CHEROKEE NATIONAL MUSEUM

CHEROKEE CULTURAL CENTER

PARK HILL, OKLAHOMA

CLARIFICATION DWG. TO ADDENDUM #3

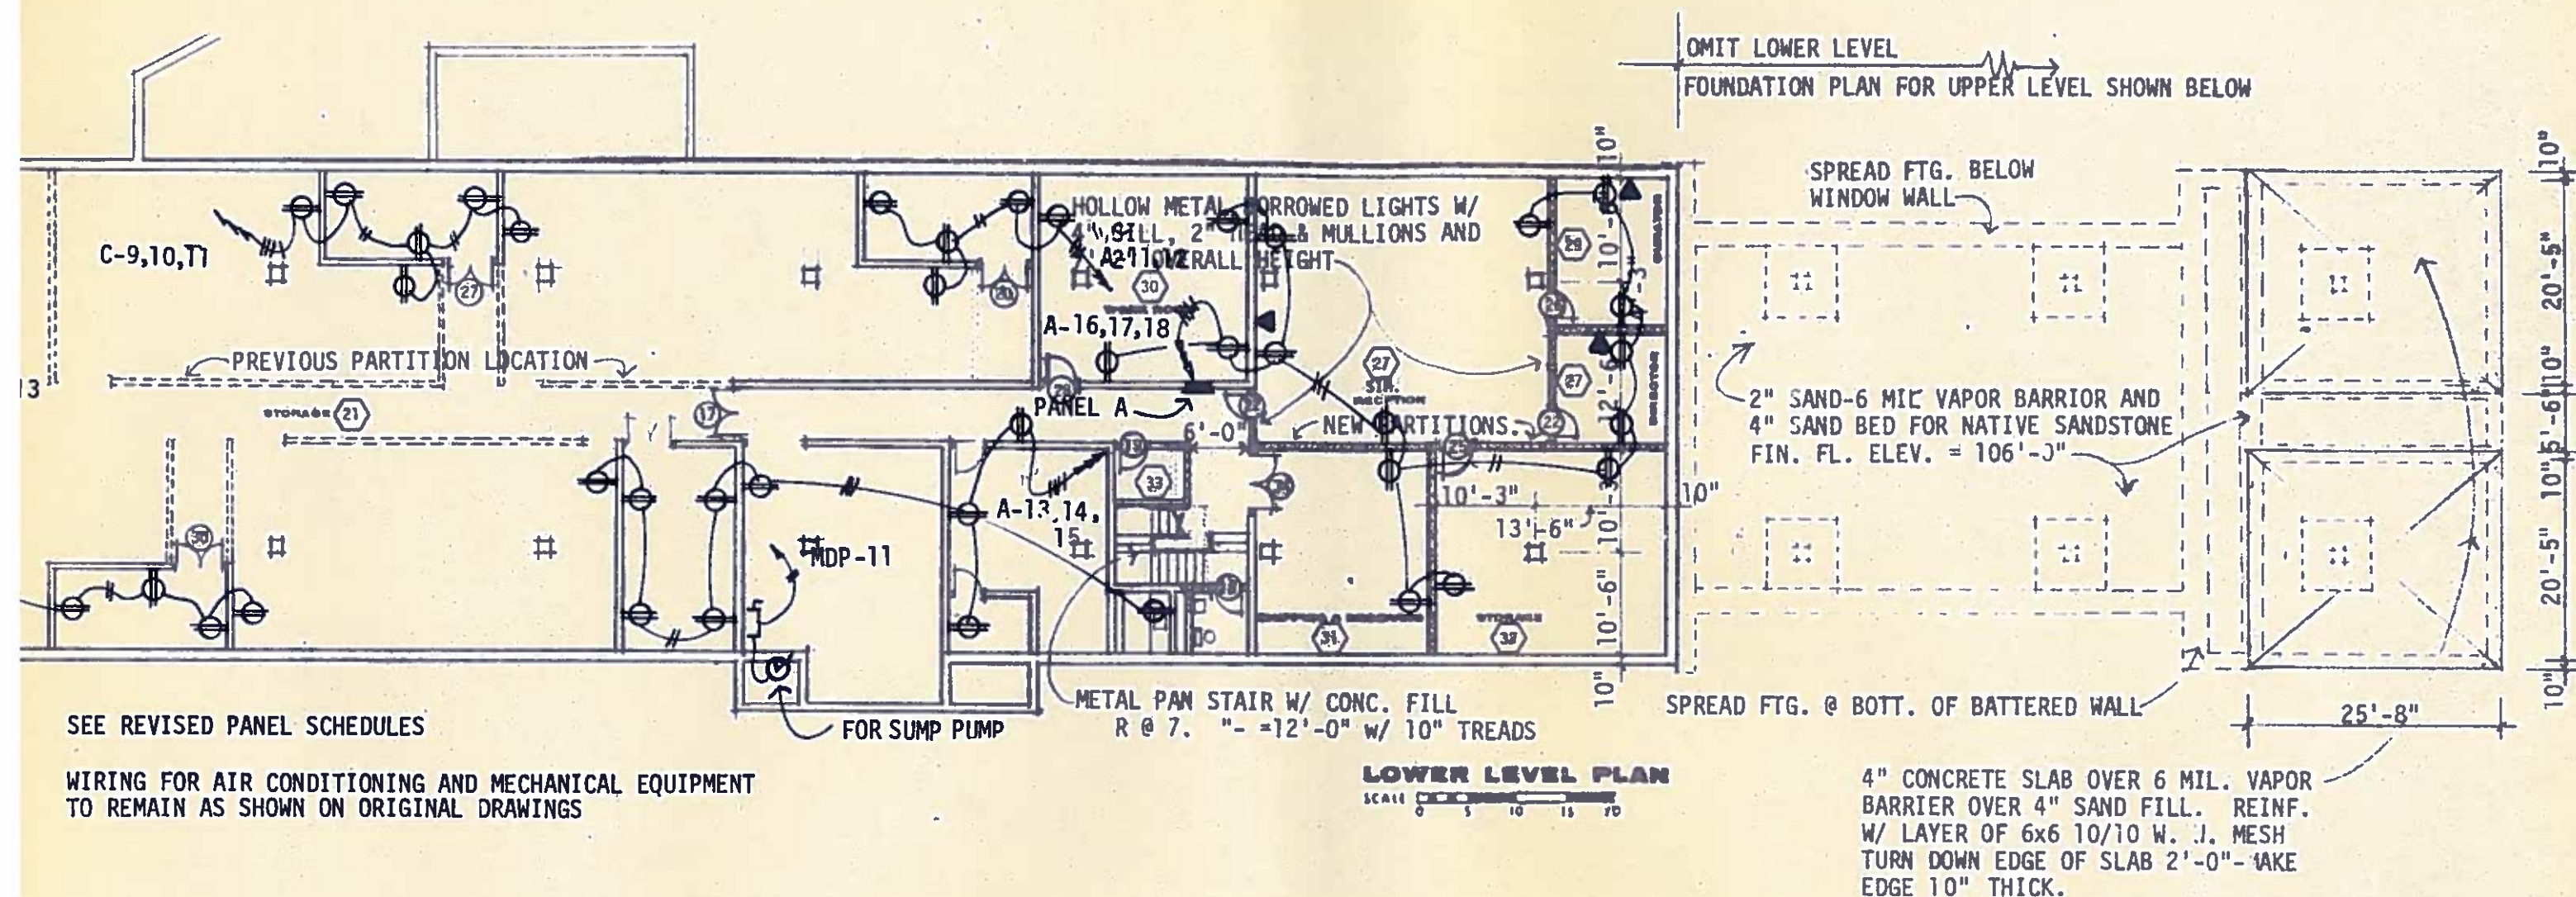
UPPER LEVEL CHANGES REQ'D FOR ALT. NO. 1

- NOTES:
1. OMIT DR 16 AND COMBINE EXIT SPACE INTO JANITOR SPACE ON UPPER LEVEL.
 2. CHANGE DR NO. 5 TO A DR SIMILAR TO DR. NO. 6 @ UPPER LEVEL.
 3. CHANGE DR. NO. 8 TO A PAIR OF 2'-6" x 7'-0" DRS W/ AN S TYPE FRAME.

LOWER LEVEL MECHANICAL CHANGES REQ'D FOR ALT. NO. 1

- NOTES:
1. OMIT 2 TYPE M FIRE DAMPERS.
 2. OMIT 1 TYPE L FIRE DAMPERS.
 3. OMIT 30'-JF 25x12 DUCT.
 4. OMIT 42' OF 18x10 DUCT.
 5. ADD 24' OF 28x28 BELOW GRADE RETURN DUCT.
 6. OMIT 4 IN DUCT FIRE DAMPERS.
 7. ZONE 3 DUCTS REMAIN IN AREA REMOVED. CHANGE DUCTS TO BELOW GRADE TYPE. ROUND DUCTS ACCEPTABLE.
 8. RELOCATE PLUMBING FOR REVISED TOILET & WORK SHOP SINK LOCATIONS.

LOWER LEVEL ELECTRICAL CHANGES REQ'D FOR ALT. NO. 1

- NOTES:
1. OMIT 11 TYPE 5 LIGHT FIXTURES
 2. OMIT CIRCUITS A-1, 2 & 3.
 3. OMIT 7 TYPE 6 LIGHT FIXTURES.
 4. OMIT 7 TYPE 7 LIGHT FIXTURES.

CLARIFICATION DWG. TO ADDENDUM # 3

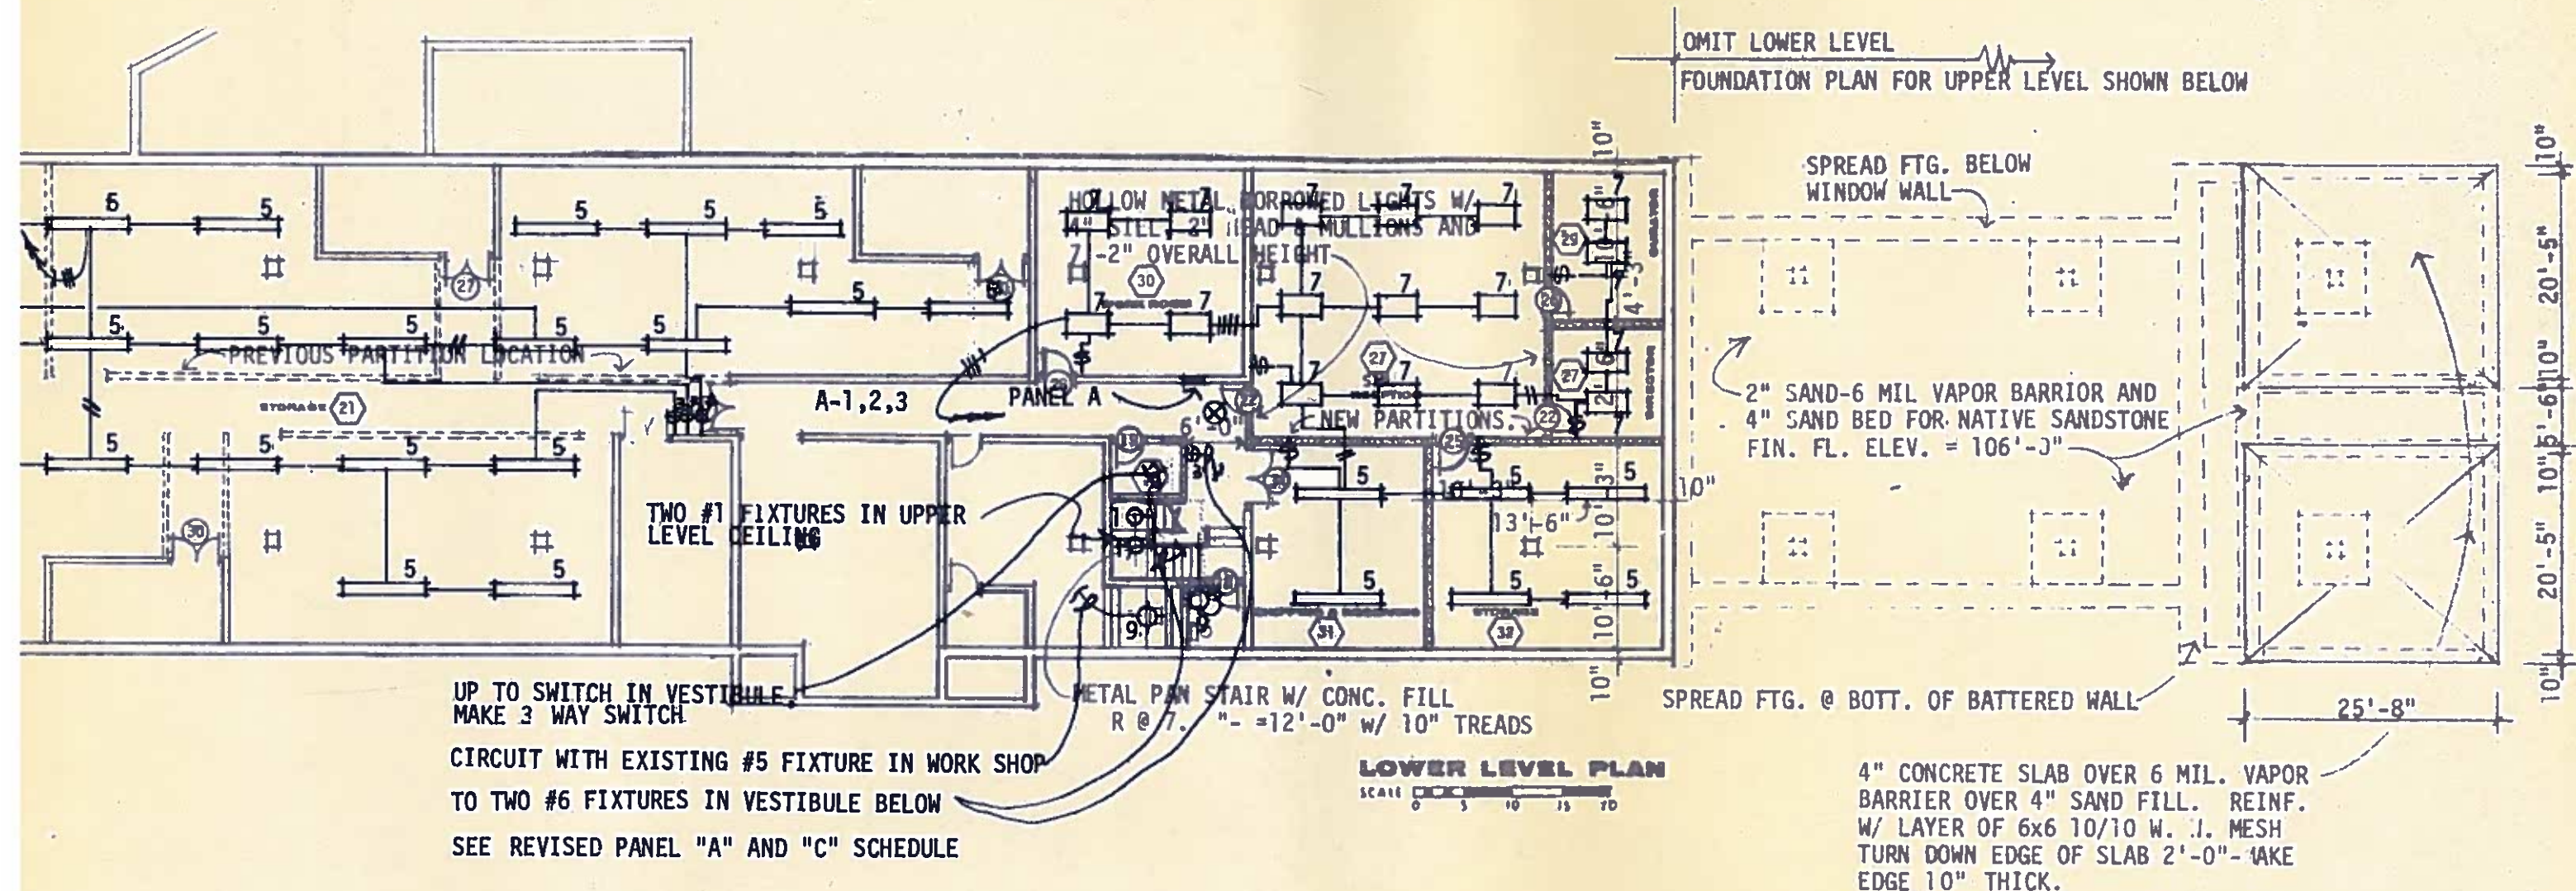
UPPER LEVEL CHANGES REQ'D FOR ALT. NO. 1

- NOTES:
1. OMIT DR 16 AND COMBINE EXIT SPACE INTO JANITOR SPACE ON UPPER LEVEL.
 2. CHANGE DR NO. 5 TO A DR SIMILAR TO DR. NO. 6 @ UPPER LEVEL.
 3. CHANGE DR. NO. 8 TO A PAIR OF 2'-6" x 7'-0" DRS W/ AN S TYPE FRAME.

LOWER LEVEL MECHANICAL CHANGES REQ'D FOR ALT. NO. 1

- NOTES:
1. OMIT 2 TYPE M FIRE DAMPERS.
 2. OMIT 1 TYPE L FIRE DAMPERS.
 3. OMIT 30' OF 25x12 DUCT.
 4. OMIT 42' OF 18x10 DUCT.
 5. ADD 24' OF 28x28 BELOW GRADE RETURN DUCT.
 6. OMIT 4 IN DUCT FIRE DAMPERS.
 7. ZONE 3 DUCTS REMAIN IN AREA REMOVED. CHANGE DUCTS TO BELOW GRADE TYPE. ROUND DUCTS ACCEPTABLE.
 8. RELOCATE PLUMBING FOR REVISED TOILET & WORK SHOP SINK LOCATIONS.

LOWER LEVEL ELECTRICAL CHANGES REQ'D FOR ALT. NO. 1

- NOTES:
1. OMIT 11 TYPE 5 LIGHT FIXTURES
 2. OMIT CIRCUITS A-1,2 & 3.
 3. OMIT 7 TYPE 6 LIGHT FIXTURES.
 4. OMIT 7 TYPE 7 LIGHT FIXTURES.

ISOMETRIC OF MECHANICAL ROOM

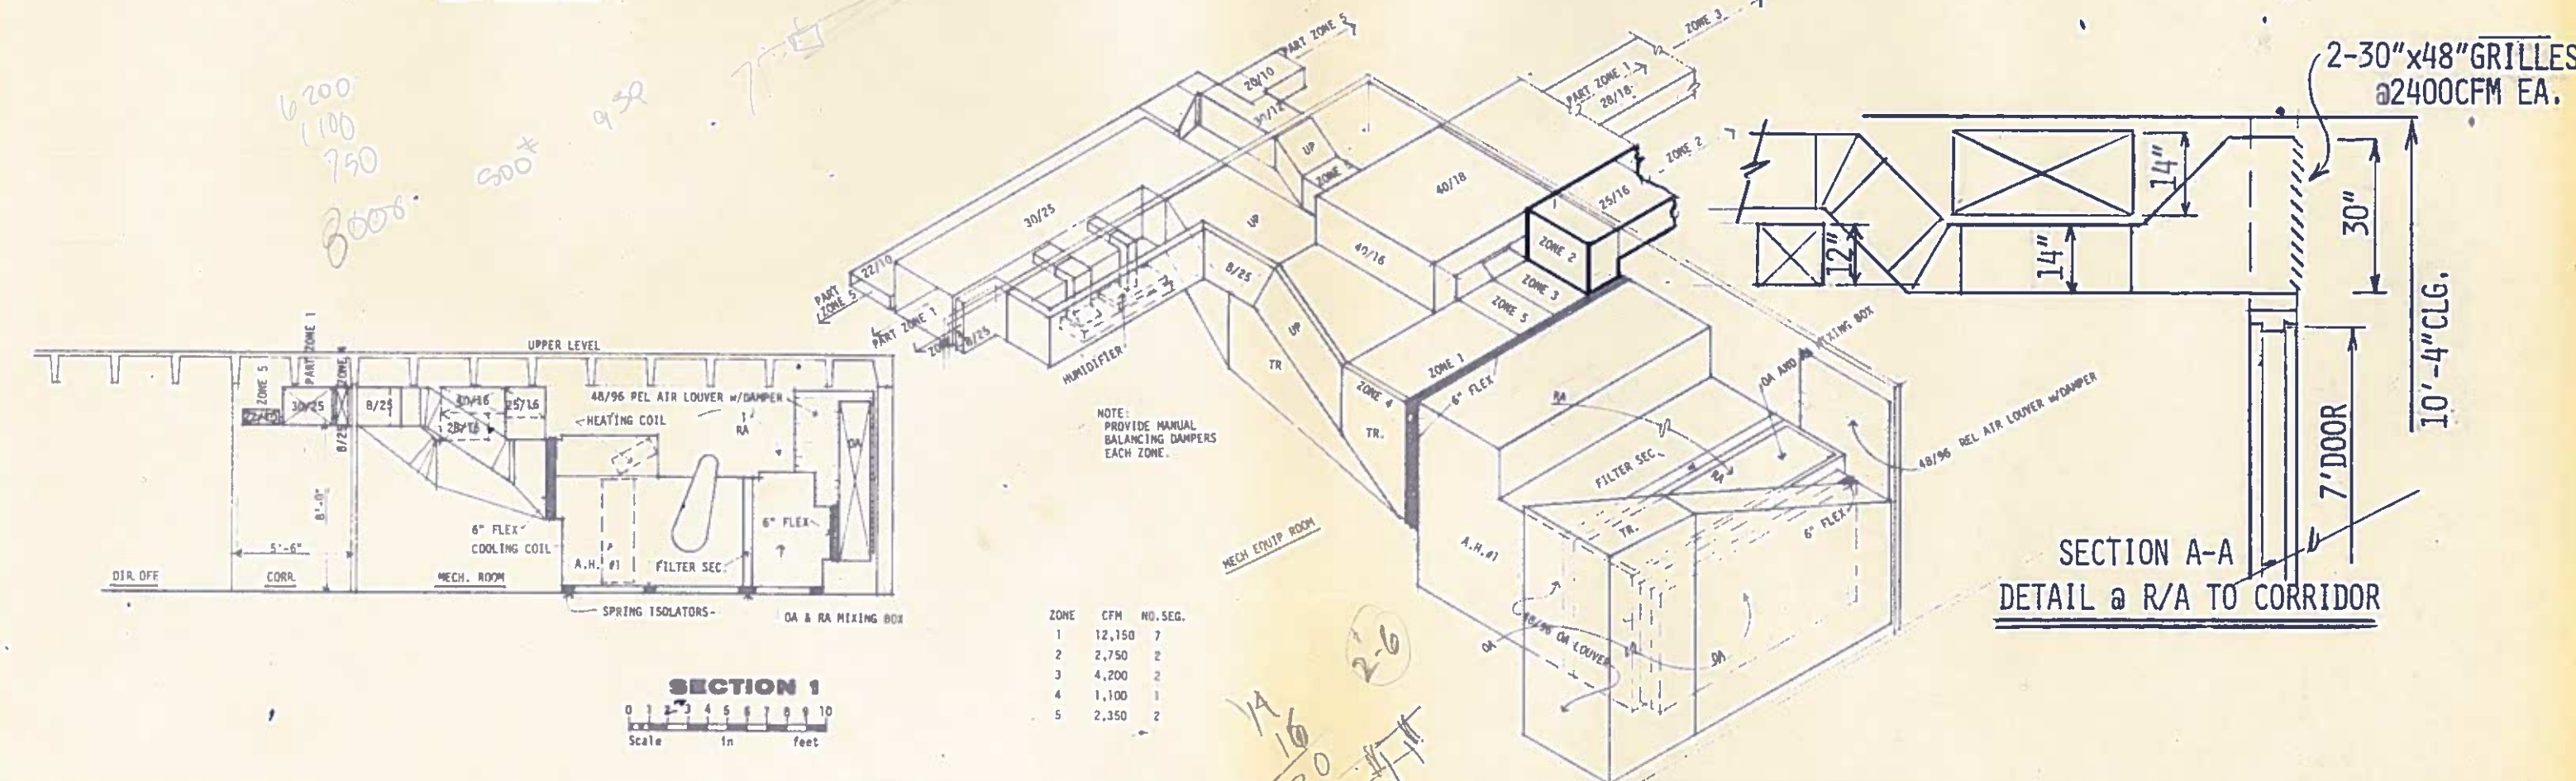
NEW PARTITIONS
HOLD DUCT LOW TO BRANCH UNDER 28/18
BOLD LINES INDICATE CHANGES COVERED IN ADDENDUM NO.3
LOWER LEVEL MECHANICAL PLAN
